ADDENDUM NO. 1

April 1, 2022

**PROJECT: Jerome Elementary School
Jerome School District
Jerome, Idaho**

⑤ FIRE WALL TERMINATION 4
3/4" = 1'-0"

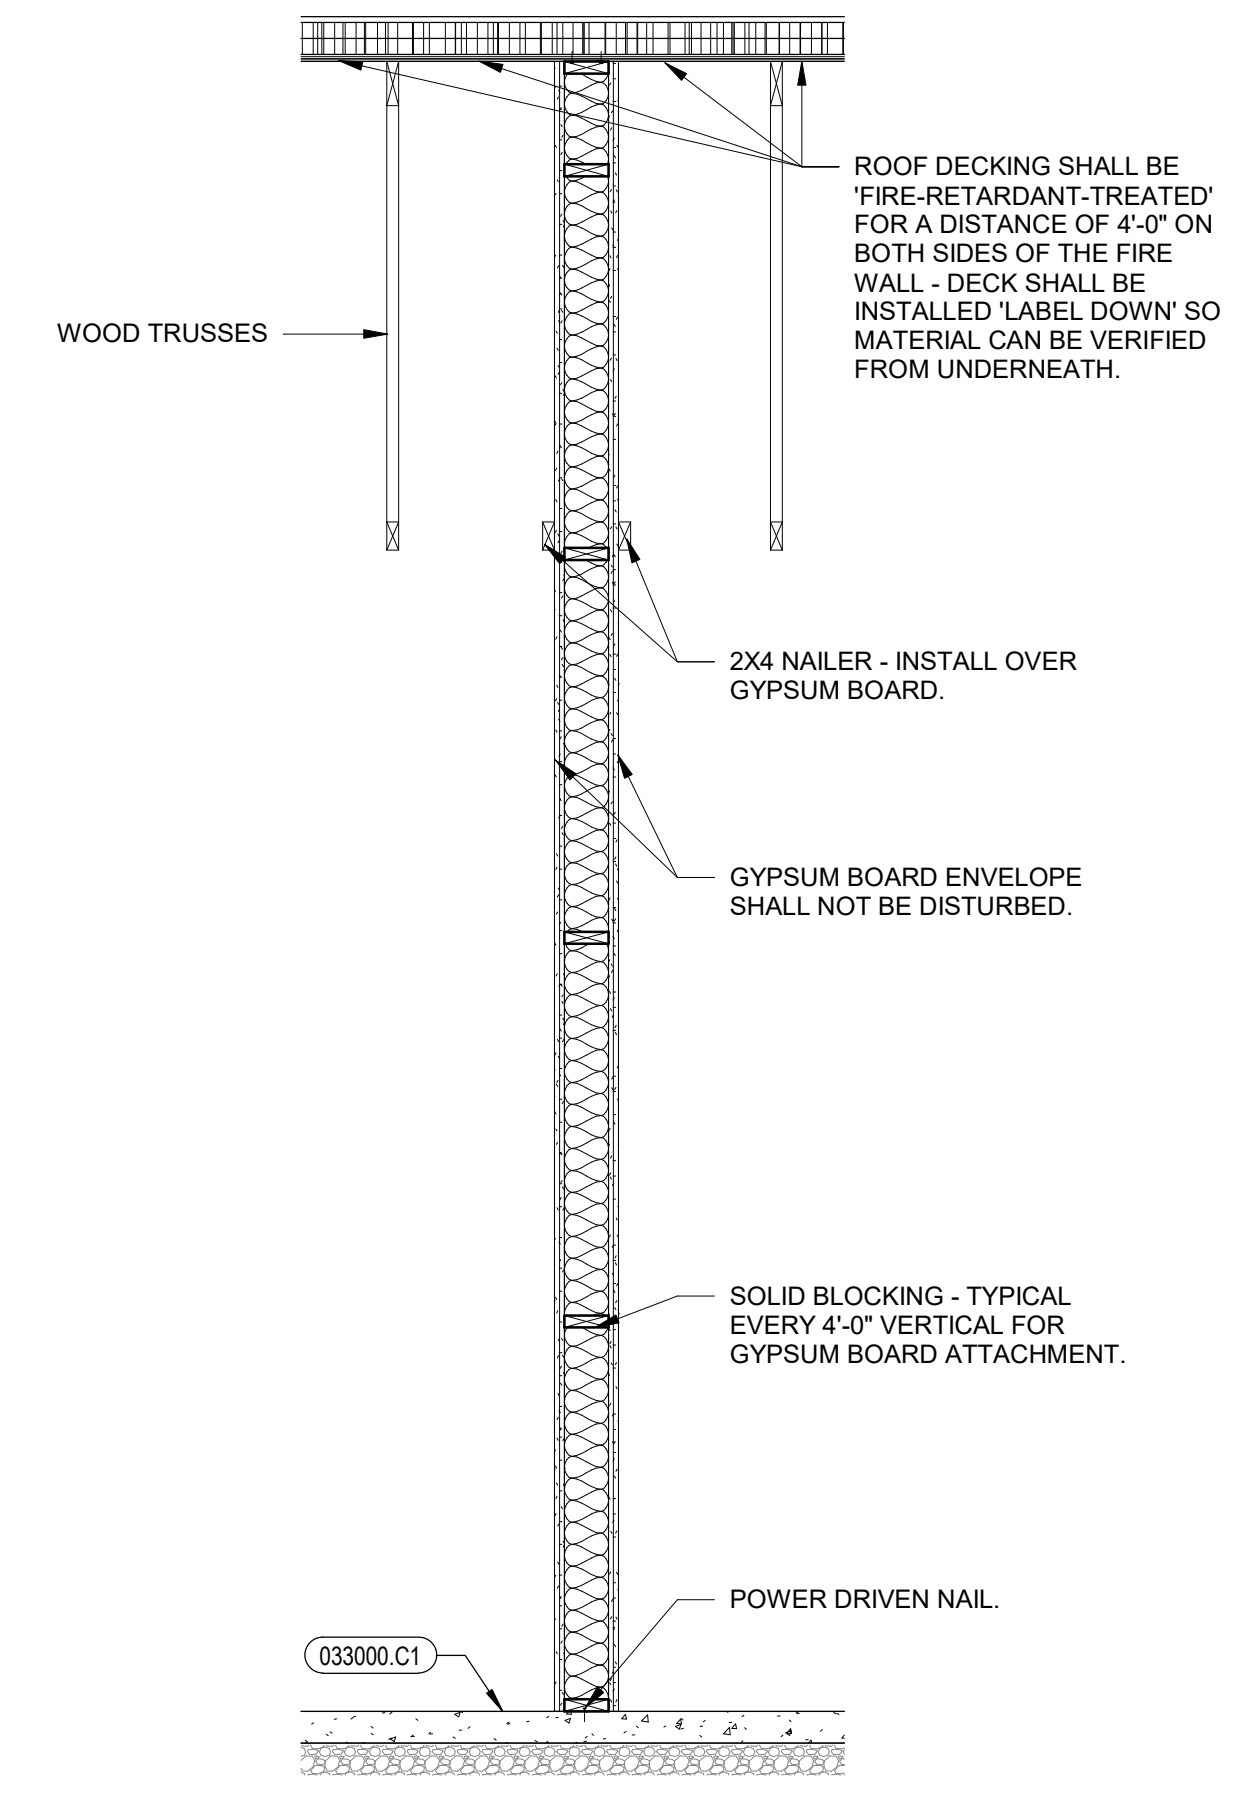
1. Provide new fire wall termination detail 5/A1.3, per revised Sheet A1.3, attached.

1 FLOOR PLAN - AREA F
1/8" = 1'-0"

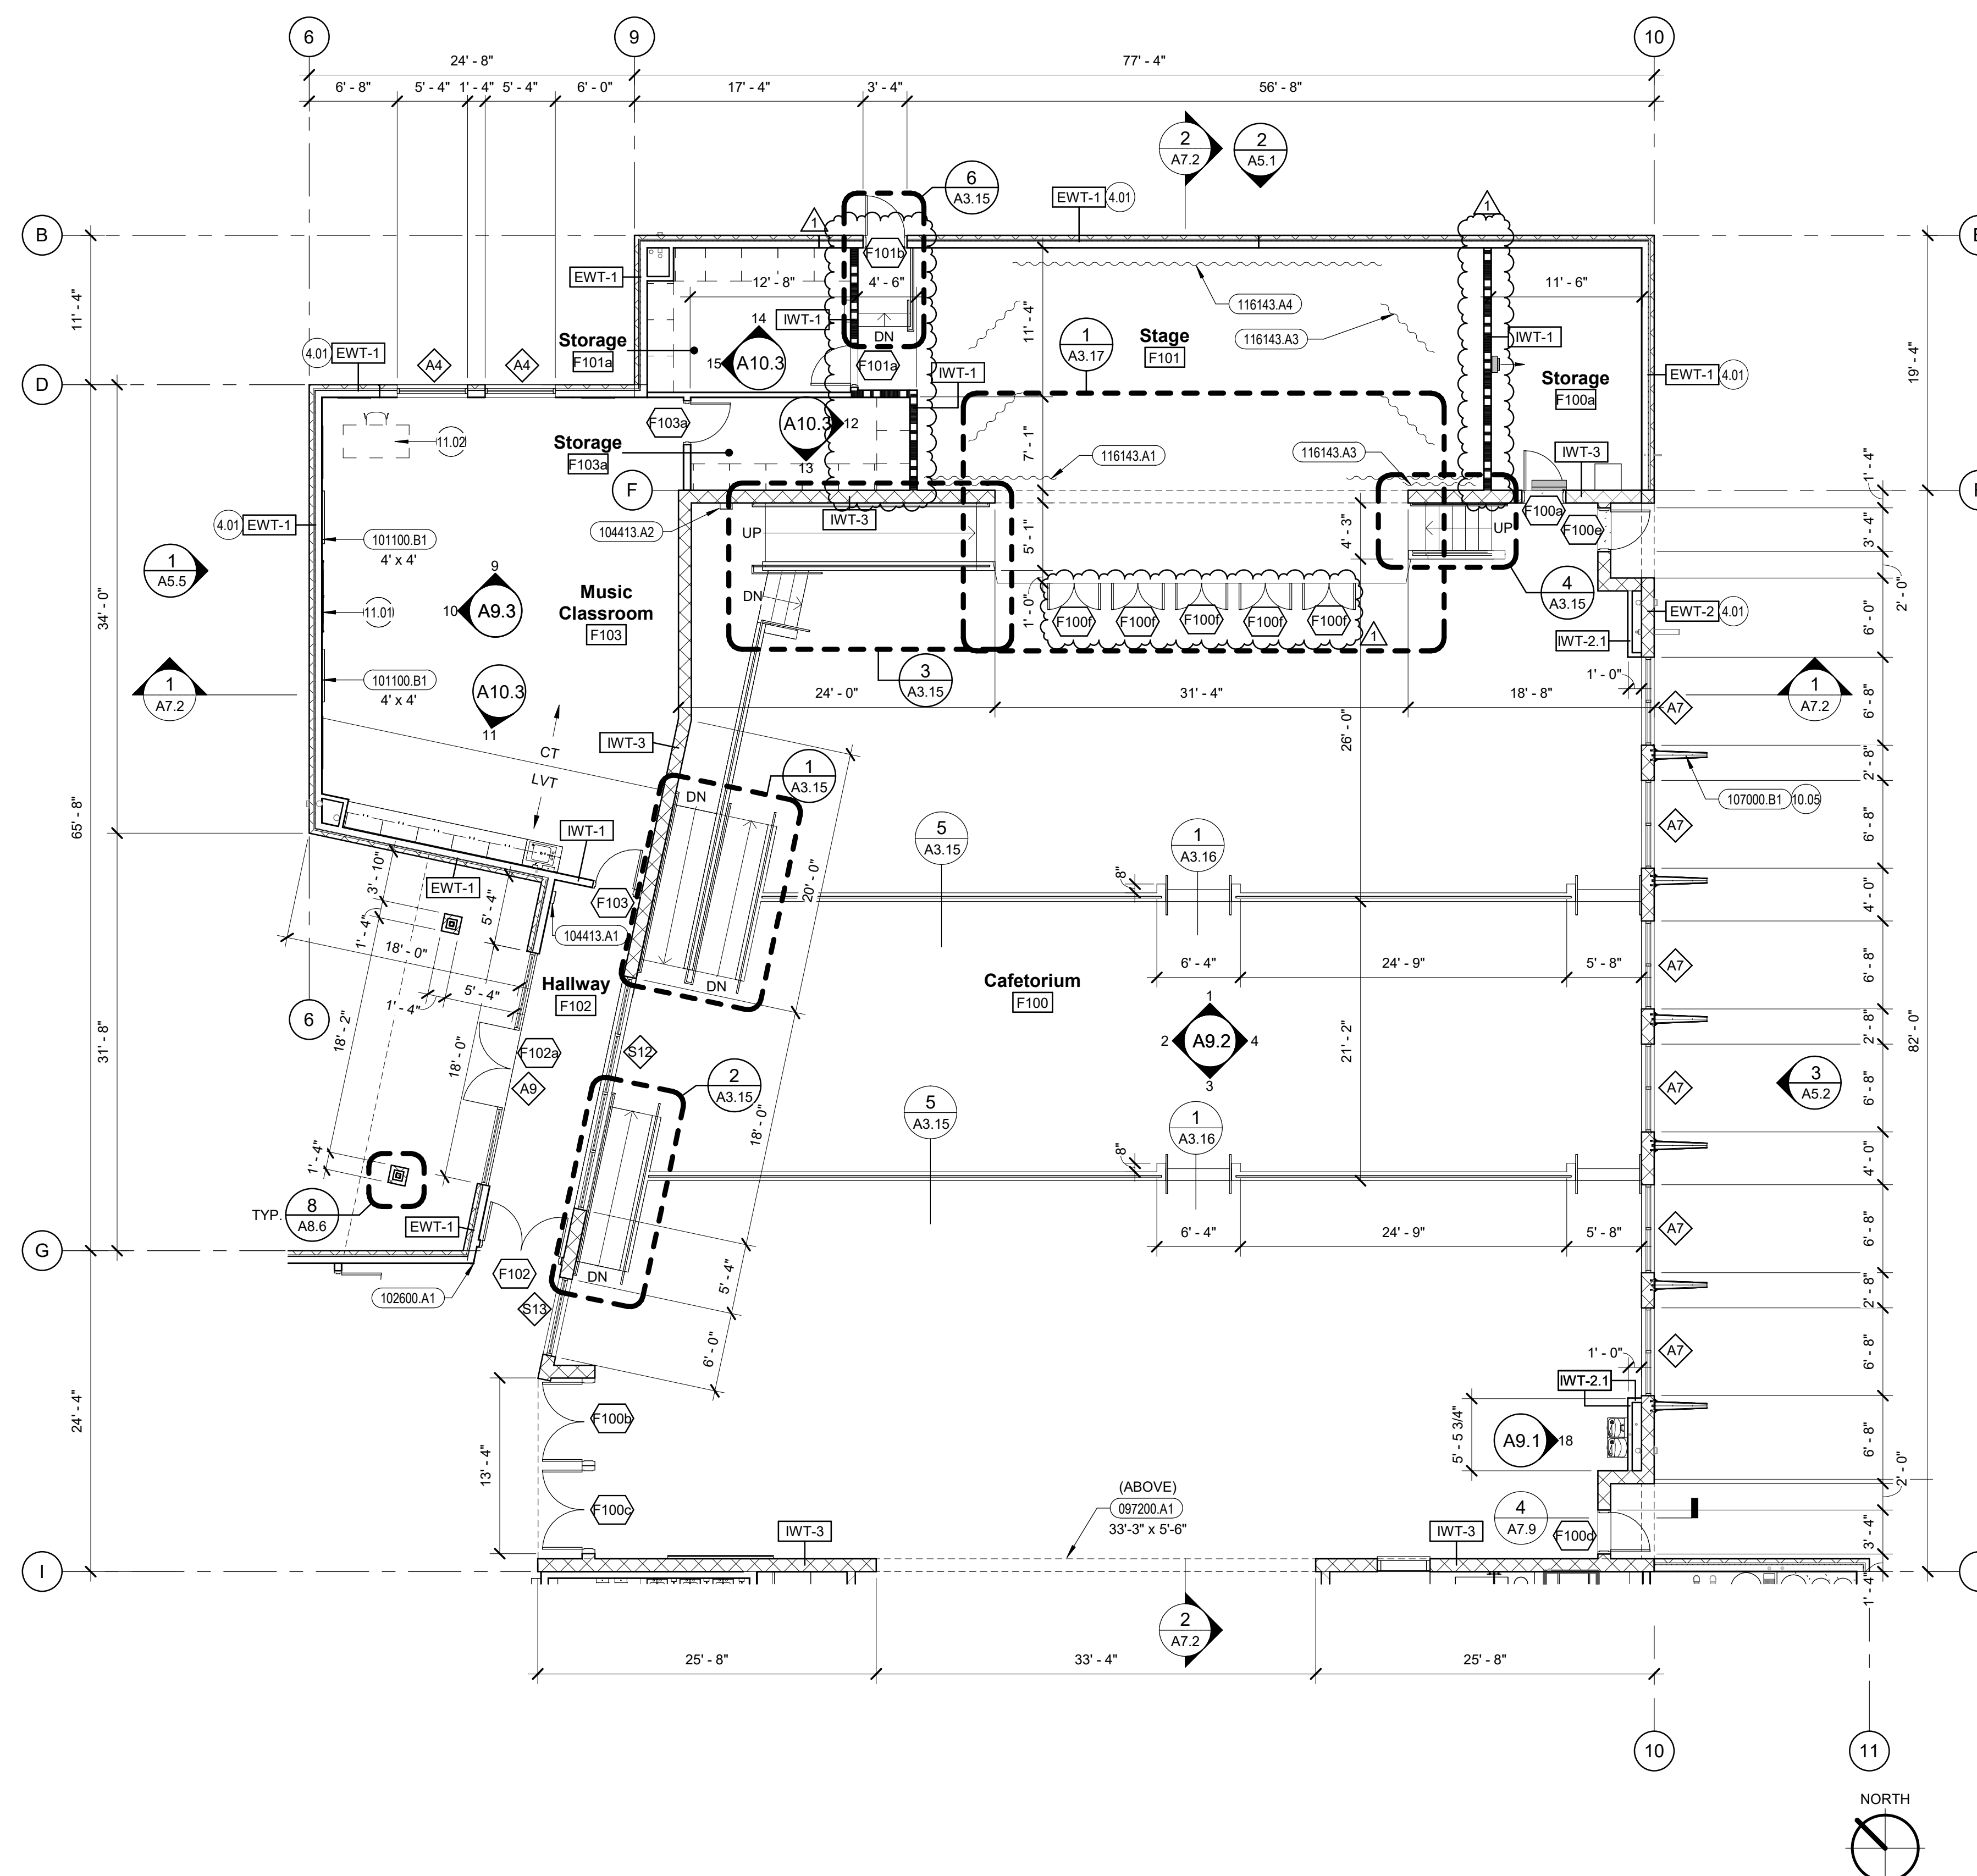
1. Revise wall types to be fire rated walls at Stage F101 as shown per revised Sheet A3.7, attached.
2. Revise door F101a to be 20-minute rated door construction.
3. Under stage doors shall be 4'-0" x 2'-3". Door type A2, Flush wood, Stain.
